Lot 4, SSC Subdivision, County of El Paso, State of Colorado.

8-20-2019 - County Comments, add parking

SITE PLAN

PROJECT No. 18326
 JANUARY 10, 2019
 SHEET 1 OF 1

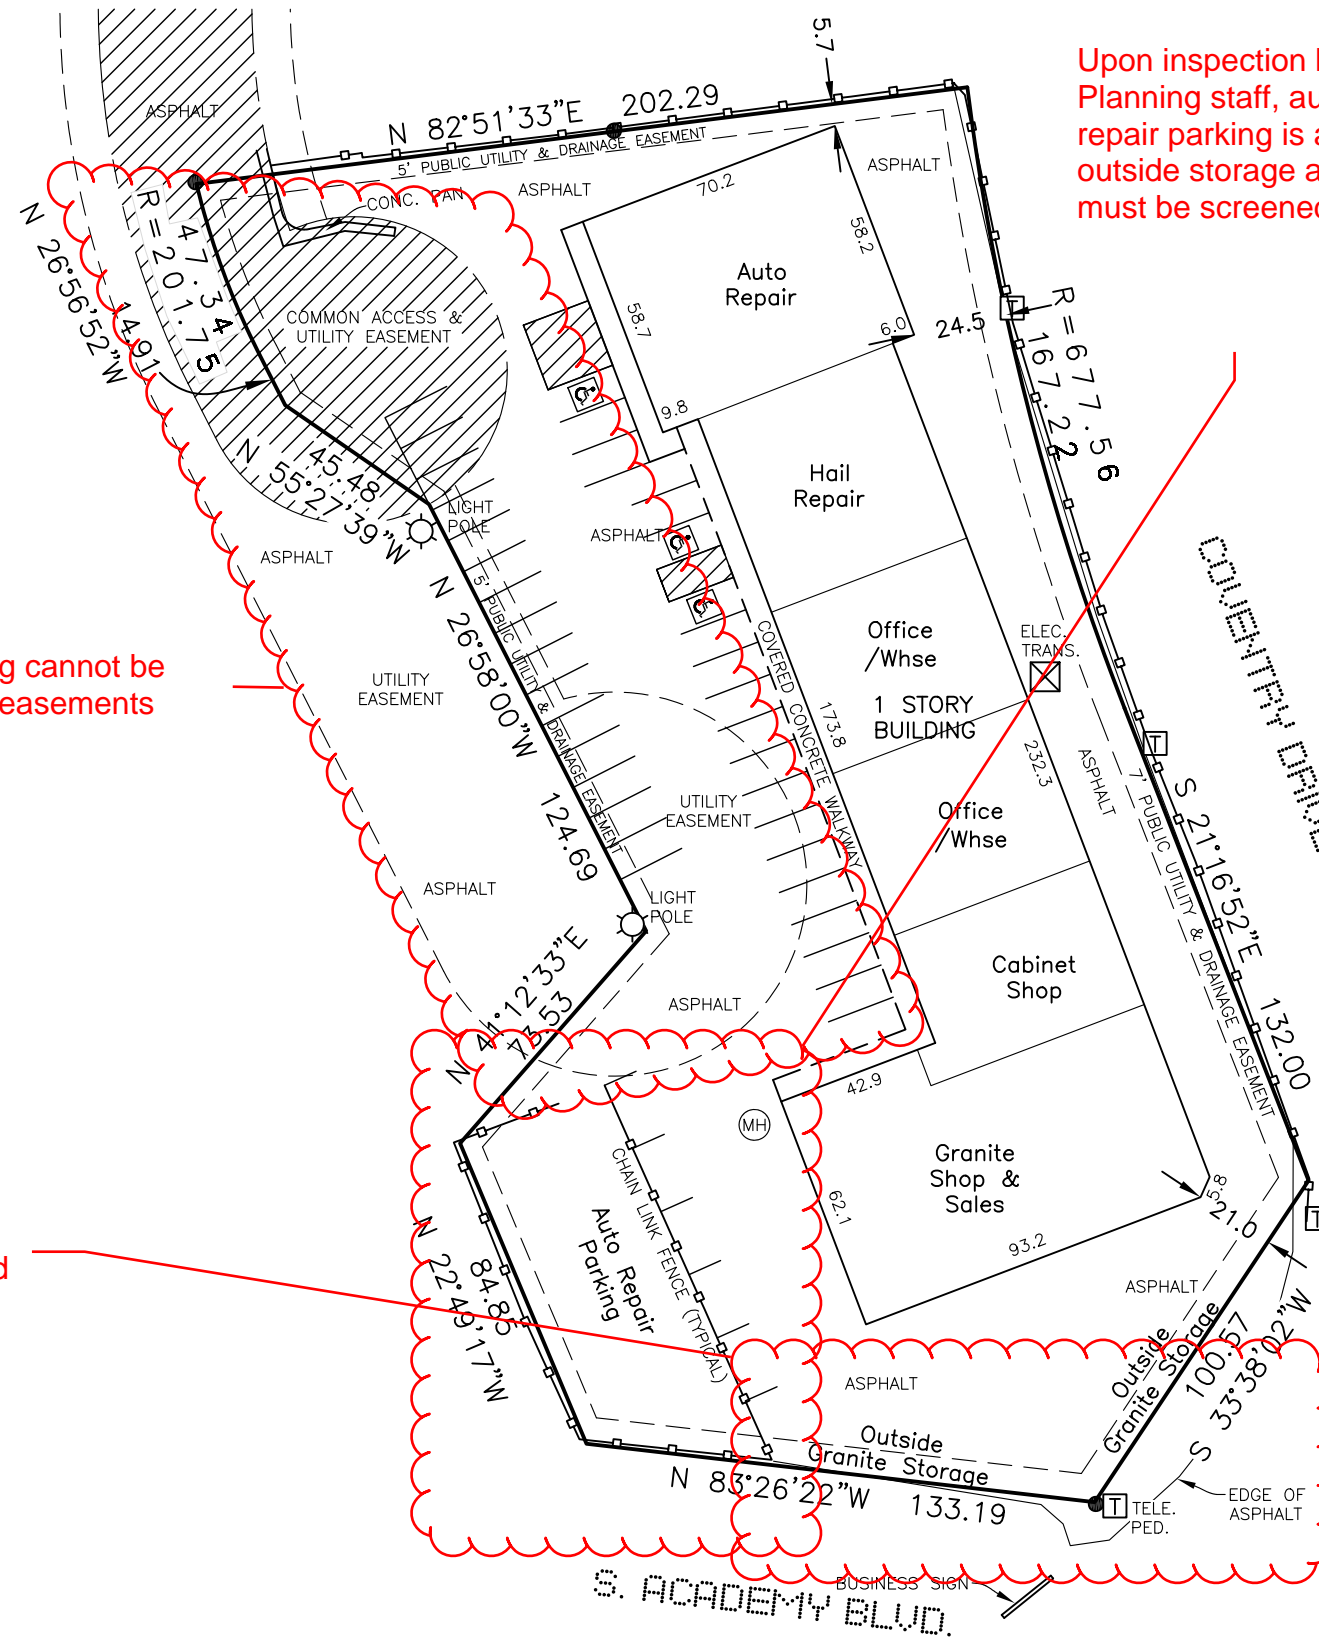
An alternative landscaping plan will be required - see section 6.2.2 of the land development code
 Parking detail is required for each use - see chapter 6 table 6-2 for parking requirements and uses
 Loading area and bays must be shown for parking detail

Screening of outside storage is required per 5.2.37 of the land development code

Parking cannot be within easements

Upon inspection by Planning staff, auto repair parking is also outside storage and must be screened
